ALERT SERVICE BULLETIN REVISION TRANSMITTAL SHEET

MODEL BD-100-1A10 (CL-300)

Alert Service Bulletin No. A100-30-03

Revision No. 01 Dated Dec 21/2005

Figure 1

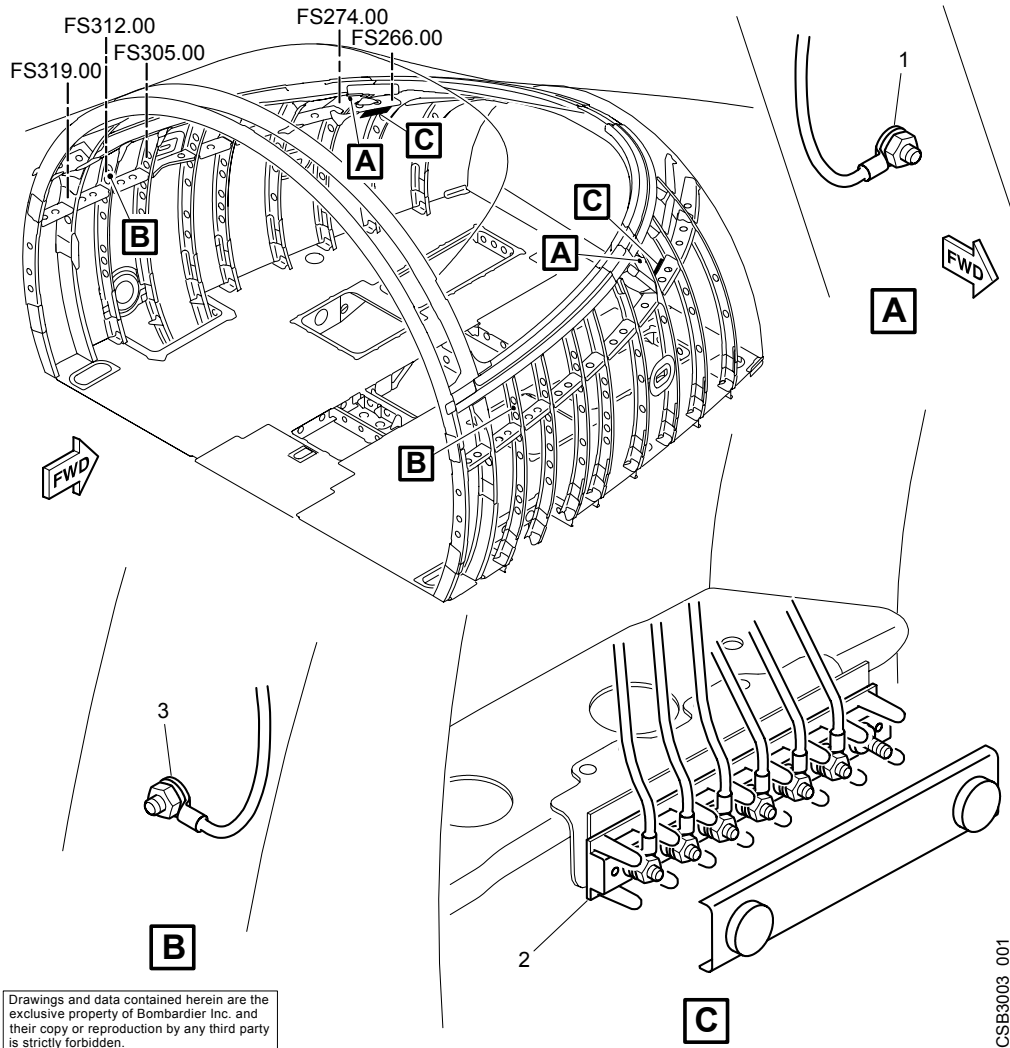
2. For the location of the terminal blocks and ground studs, refer to Figure 1.
 3. Windshield terminals G, H, L1 and L2 are found at the bottom edge of each windshield section.

6. For the use of a torque wrench, refer to TASK 20-20-00-910-802.
- (1) Remove the cover from terminal blocks TB3 and TB4.
 - (2) Make sure that the electrical connections at terminal blocks TB3 and TB4 are tightened to 24 to 30 lbf in (2.7 to 3.4 Nm).

- (3) Install the cover back onto terminal blocks TB3 and TB4.
 - (4) Make sure that the electrical connections at ground studs GS2269 and GS2270 are tightened to 65 to 75 lbf in (7.4 to 8.5 Nm).

- (5) Make sure that the electrical connections at ground studs GS2273 and GS2274 are tightened to 32 to 37 lbf in (3.7 to 4.2 Nm).
